National Electrical Safety Code
Interpretations
1981—1984 inclusive

**ANSI/IEEE C2
Interpretations 1981-1984**

This edition includes official interpretations of the National Electrical Safety Code as made by the Interpretations Subcommittee of the National Electrical Safety Code Committee, ANSI C2.

Fig IR 284-2

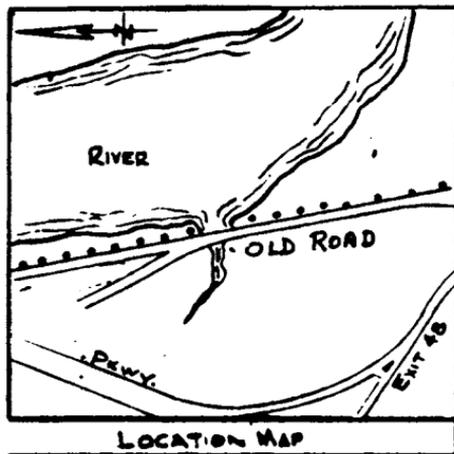
- (2) Are the clearances as specified in Table 232-1, item 7, intended to apply to an "overhanging line" situation as described above?
- (3) If Table 232-1, item 7, does apply would 7(d) be the required clearances since the river does provide access to the Atlantic Ocean? (Ref: Last sentence of Footnote 17.) If not 7(d), what acreage would apply?
- (4) In reference to the statements in Table 232-1, Footnote 17, that begin with "The clearance over . . ." etcetera, is the word "over" intended to imply a line crossing that goes from one side to the other side of a river, stream or canal in a way that it may restrict vessel height and normal water travel or is it intended to imply simply wherever there is water under the line and that water is any portion of a body of water suitable for sailboating?

As to question 3, Table 232-1 item 7 does apply (specifically the clearances of 7-d)

Regarding question 4, the clearance required would be as shown for item 7. The area adjacent to the boat ramp would come under item 8.

Fig IR 306

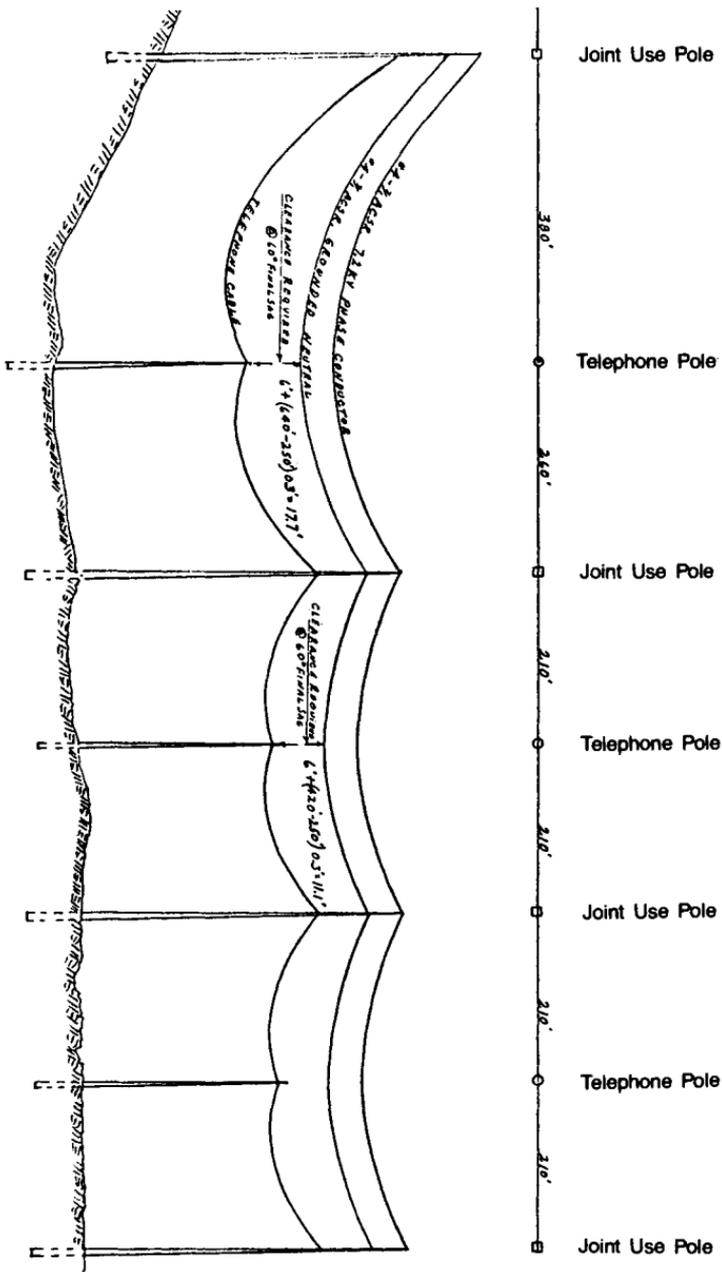
Is this the right interpretation?

Fig IR 323

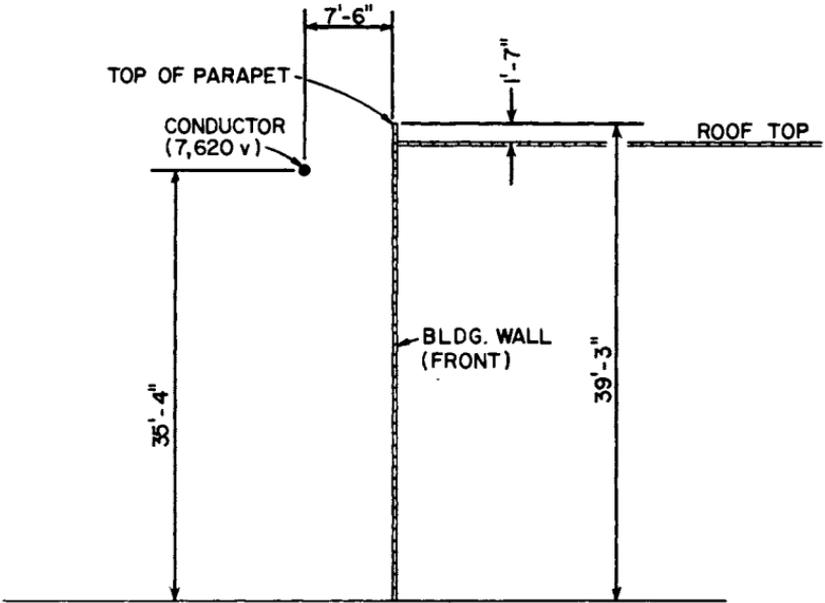
- (1) Does the electrical distribution conductor, as shown on the attached sketch, comply with the clearance requirements prescribed by Section 234C and Table 234-1 of the 1977 edition of the National Electrical Safety Code?
- (2) Is the electrical distribution conductor, as shown on the attached sketch, complying with the five ft minimum basic horizontal requirement of Section 234C and Table 234-1 of the 1977 edition of the National Electrical Safety Code, also required to be at least 15 ft measured diagonally or on a straight line distance from the top of the parapet wall?

Fig IR 309

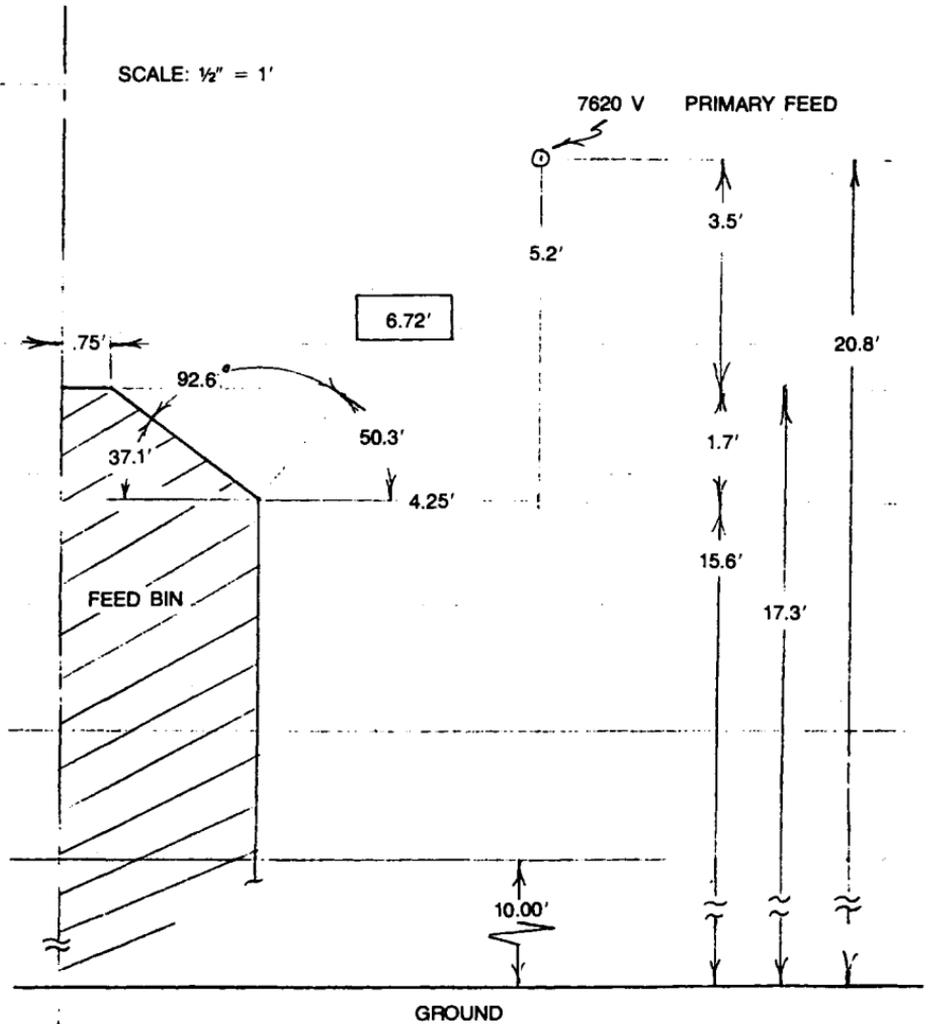
A question has arisen concerning the interpretation of the 1973 National Electrical Safety Code (NESC) in regard to the clearances between buildings and power lines. The accompanying sketch shows a feed-bin outline relative to a 7620 V primary feed line. Our questions are:

- (1) Is this line in violation of the 1973 NESC as you would interpret the Code, section 234C?
- (2) How does one interpret the NESC section 234C in applying the code to this case?

Fig IR 288

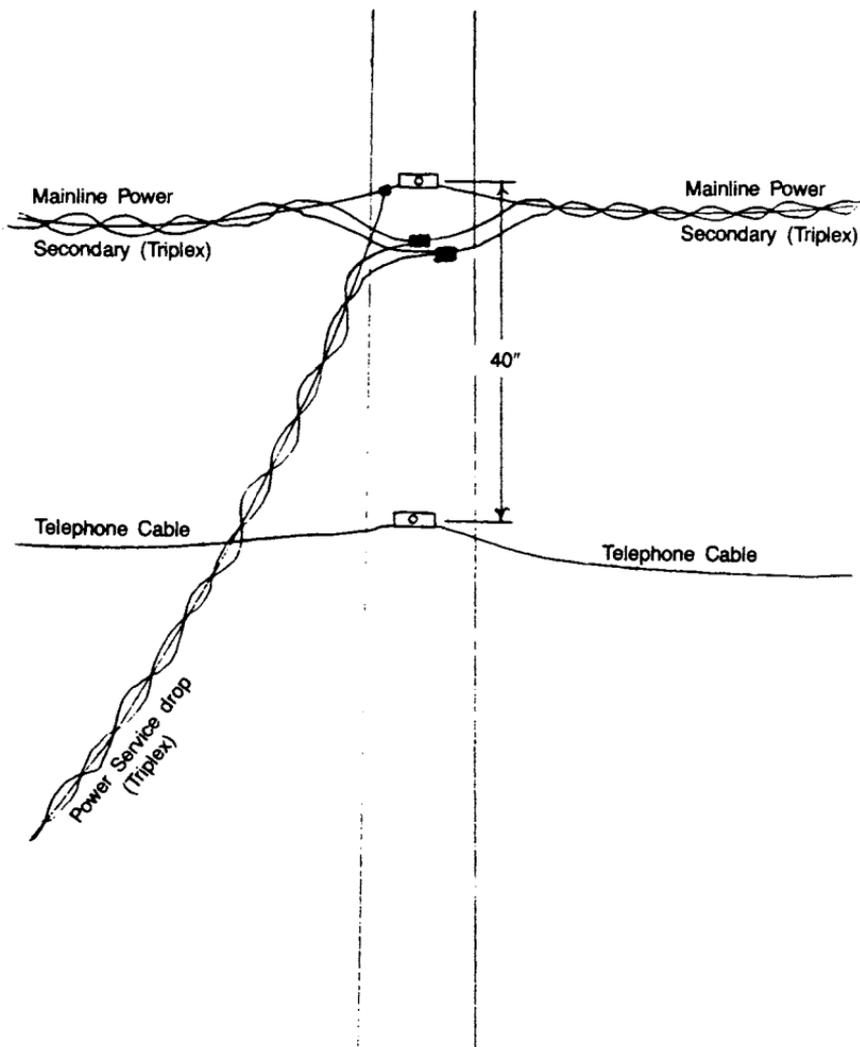
The power company feels this is the same as Rule 238D which would allow the drip loop to come within 12 in of our cable. We maintain that this violates Rule 235C which requires a minimum of 40 in clearance between the two cables.

Fig IR 330

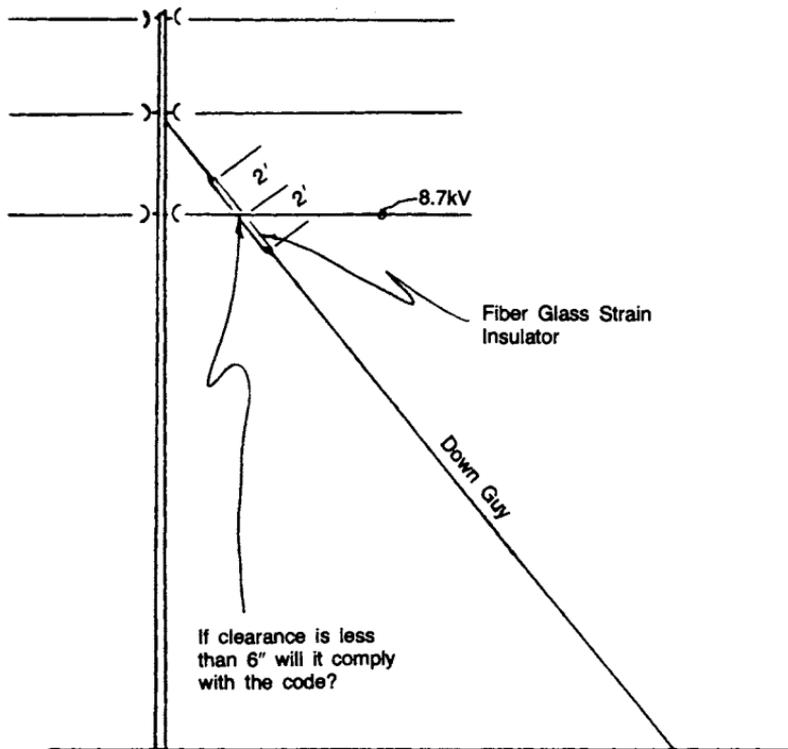
The National Electrical Safety Code (NESC), 1977 Edition, states in Table 235-6 clearance between an 8.7 kV phase and an anchor guy is 6 in. If a fiberglass strain insulator is used as shown on the attached drawing and the clearance is less than 6 in will it comply with the codes?

Fig IR 351-2

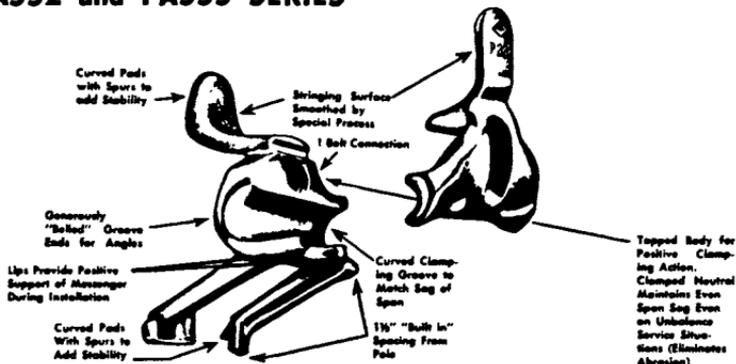
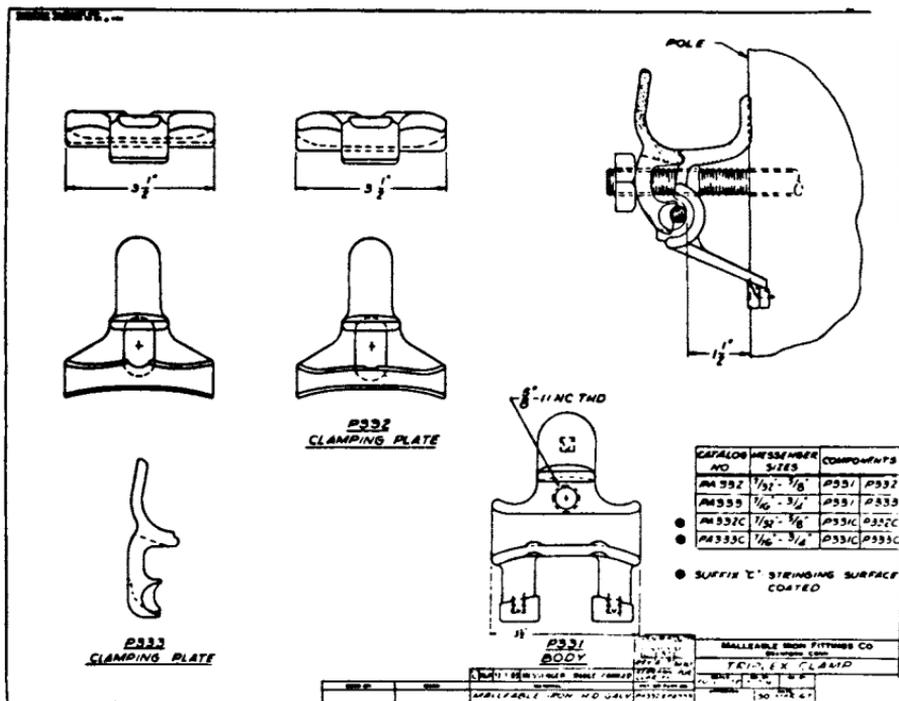
- (1) With no insulated protection in the conductor support area, are we in fact violating the intent of the Code?
- (2) If so, do we relieve the violation by insulating that surface with a nylon coating that provides 900 V per mil of thickness protection with an average thickness of 12 mils. See Fig IR 351-2.

It is my feeling that the code or intent of the Code is not violated as the approach described plus support of triplex by upset bolts has been used for many years by the majority of power customers nationally without conflict.

Fig IR 303

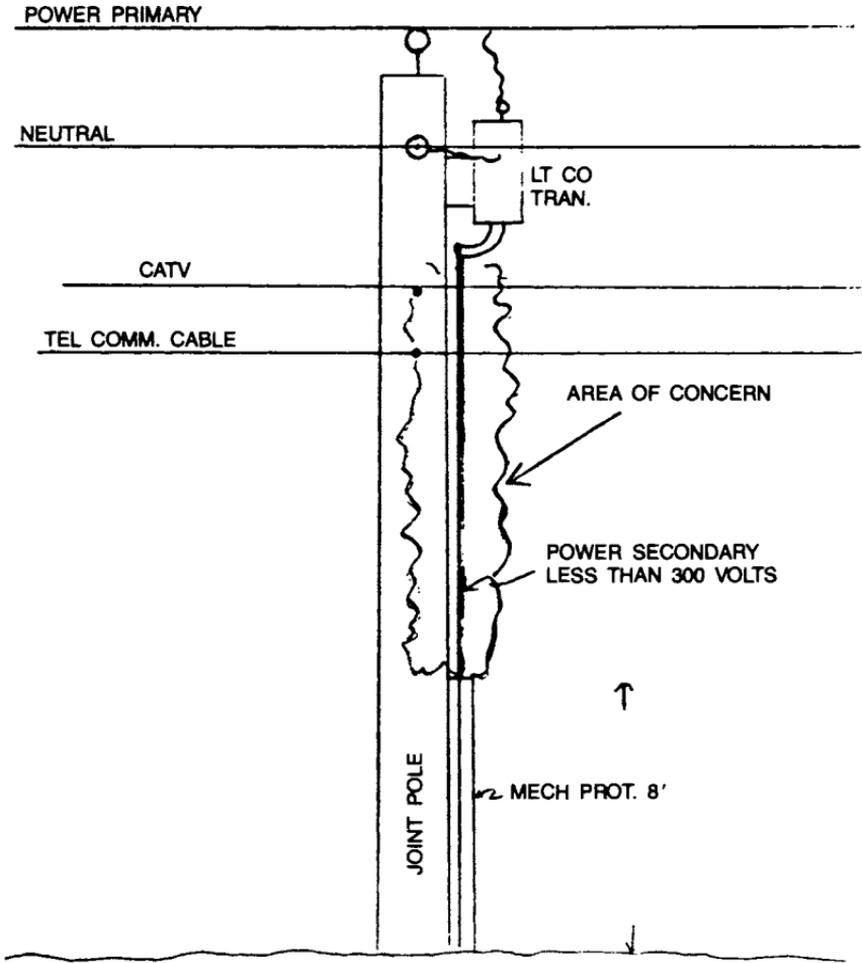
Question: What type of protection is implied? Protection against the elements or a mechanical type protection.

Fig IR 342-2

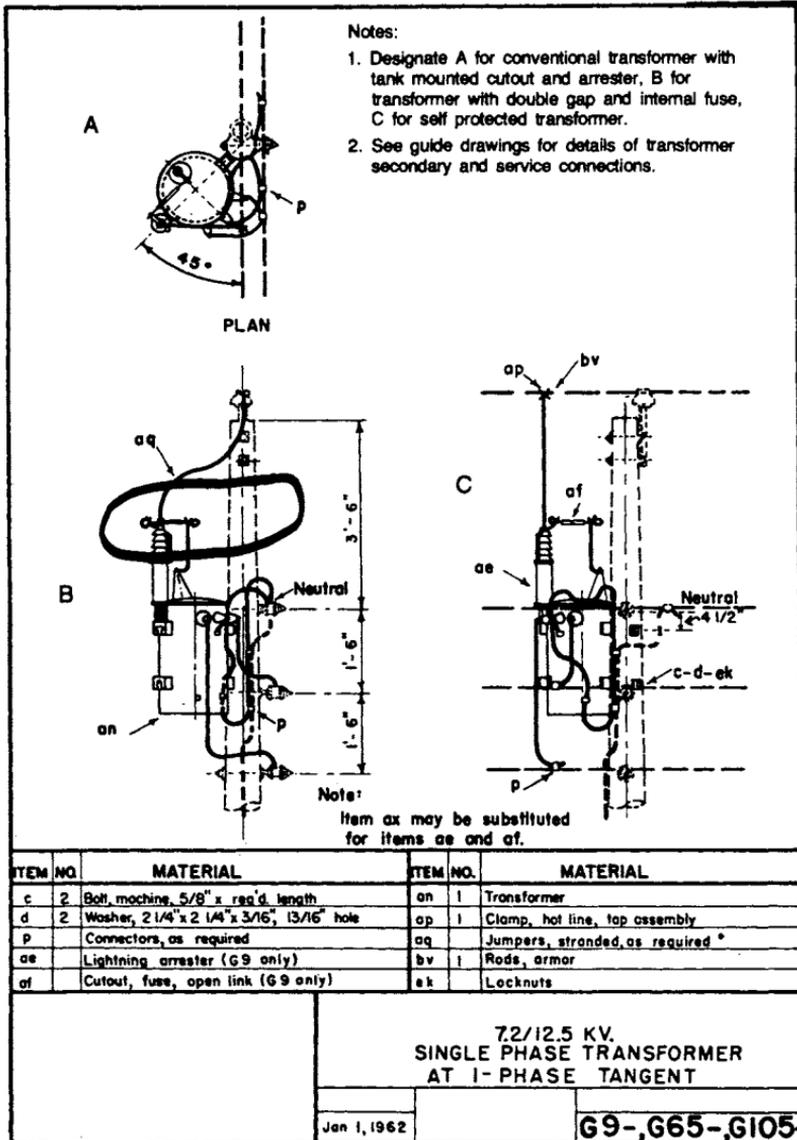
... Association operates a 7.2/12.47 kV grounded Wye system. The attached drawings, Figs IR 342-1, 2, and 3 show [our] typical and Rural Electrification Administration style installations. Unless the pole diameter is quite large, we cannot obtain the required 15 in separation between the pole center and the bushings of small transformers and oil circuit reclosers (OCR). This equipment comes with mounting brackets factory welded directly to the tank. In Fig IR 342-1 you can see that we even turned the OCR head so the bushings are parallel to the overhead line in an attempt to obtain the maximum possible separation. Yet in the smaller OCRs, we still cannot meet the 15 in requirement.

Since the equipment is manufactured with the intent of directly mounting on the pole surface using the provided bracket, we are confused as to whether or not the clearance Table 239-2 apply to the top of the equipment bushings where vertical jumpers are attached. We would greatly appreciate your help in clarifying this NESC table for us.

FIG IR 312

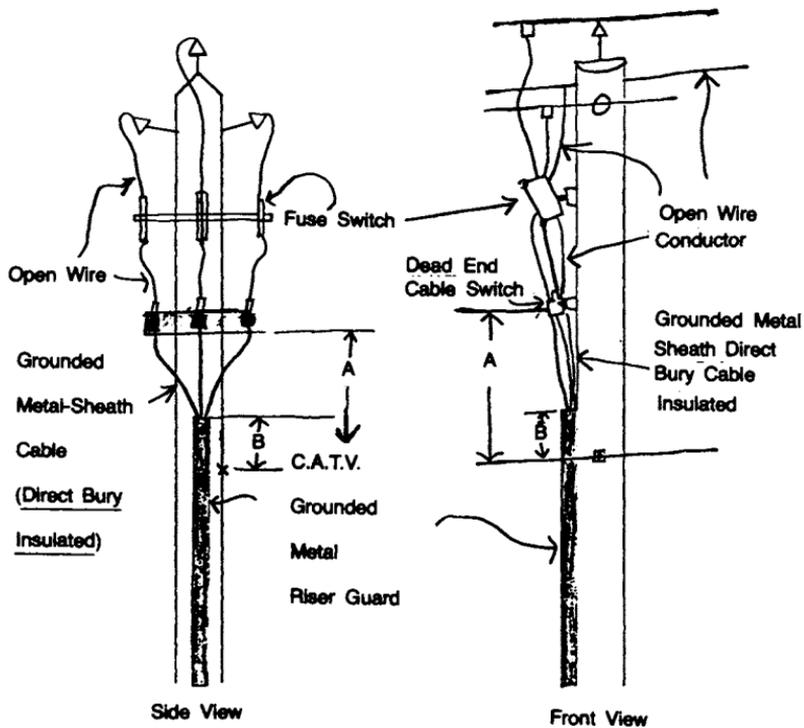
Enclosed please find a drawing [Fig IR 312] of a distribution line showing a pole with a ... Power and Light three phase primary riser.

Please include clearance for a 13 kV system and if different for a 23 kV system.

Fig IR 302-1

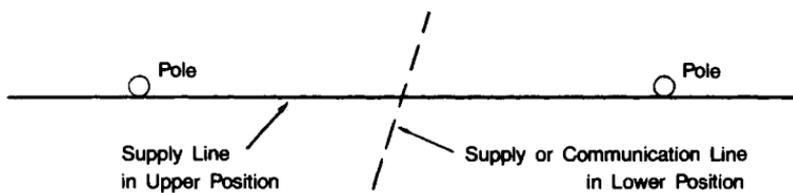
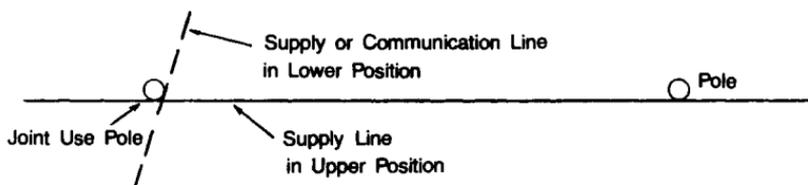
Would you please comment on these three cases and our interpretation of the meaning of the term crossing. Note that crossing is not defined in the Definitions section of the code.

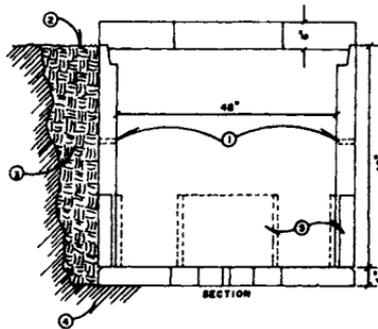
Are these structures classified as manholes or as vaults for the purpose of applying Section 323 of the National Electrical Safety Code (NESC)?

The drawing provided (Fig IR 316) shows a manhole which does NOT meet the requirements of Rules 323B or 323C1. If the opening was 26 in or larger in diameter, both rules would be met.

Fig IR 318-1

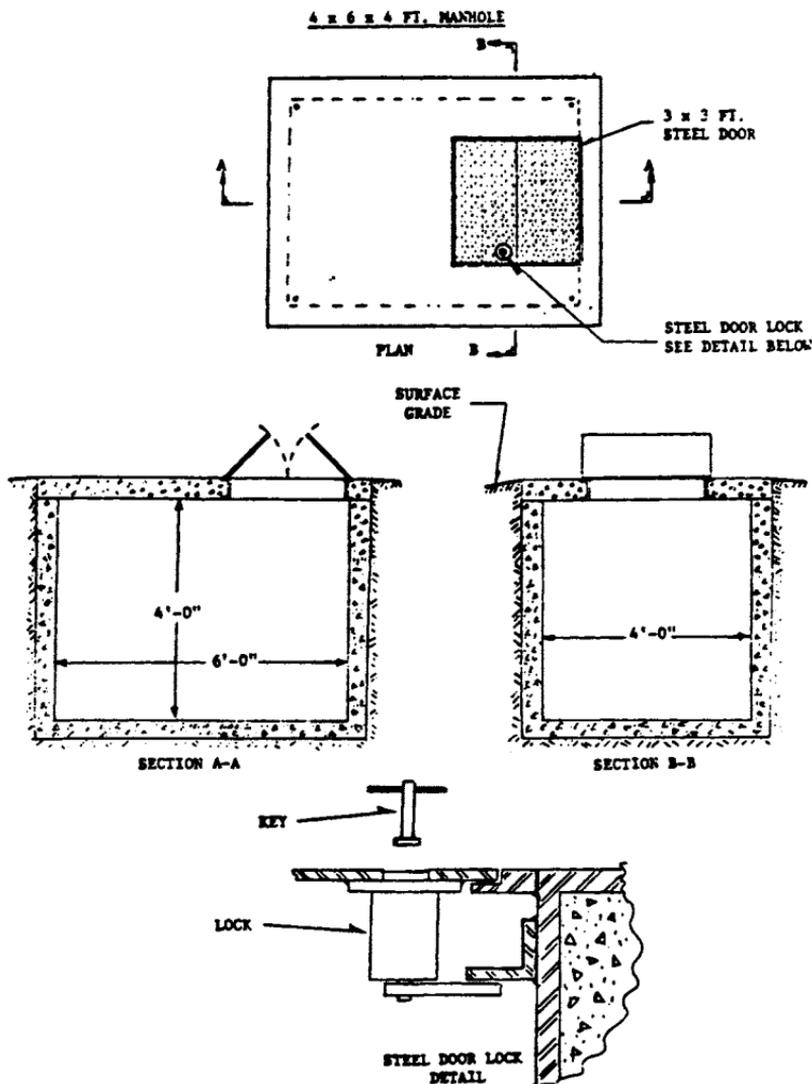
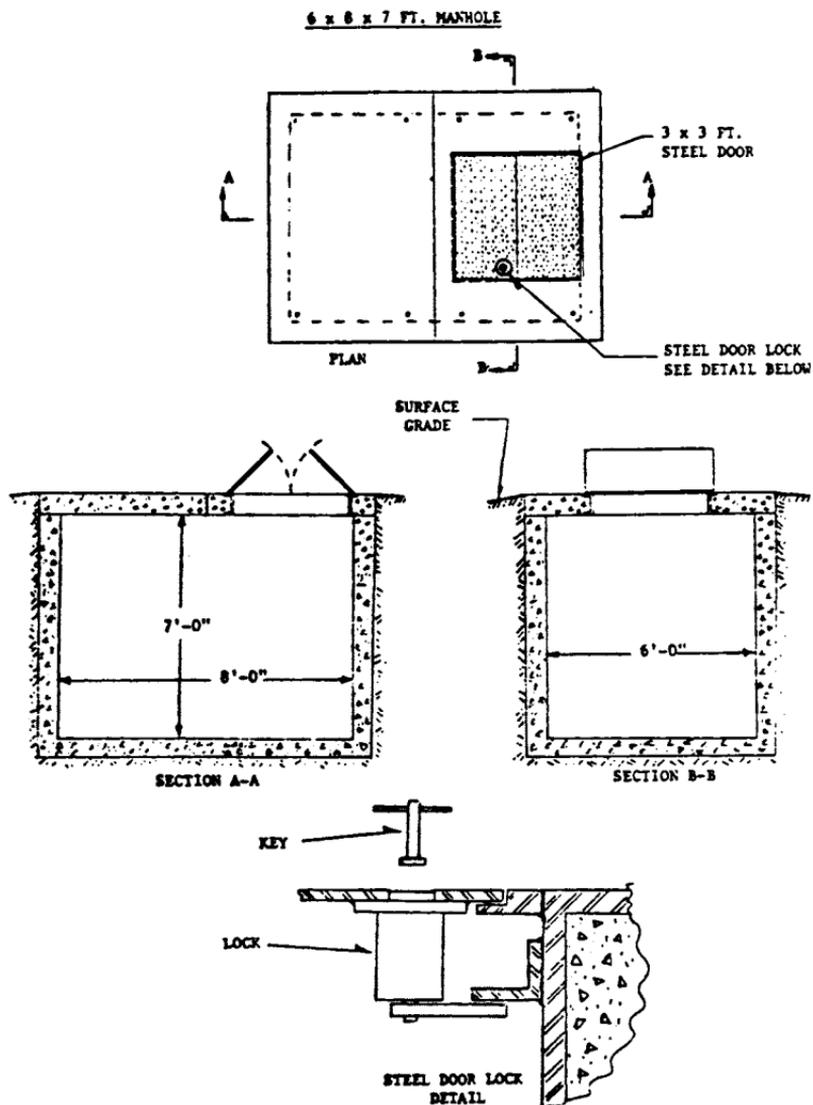
We have not had any reported cases of an employee or anyone else being locked in one of our manholes. We feel our interpretation of Rule 323F2 is supported by our manhole design and company safety procedures which provide safe access to our manholes without internal operators on the steel door locks.
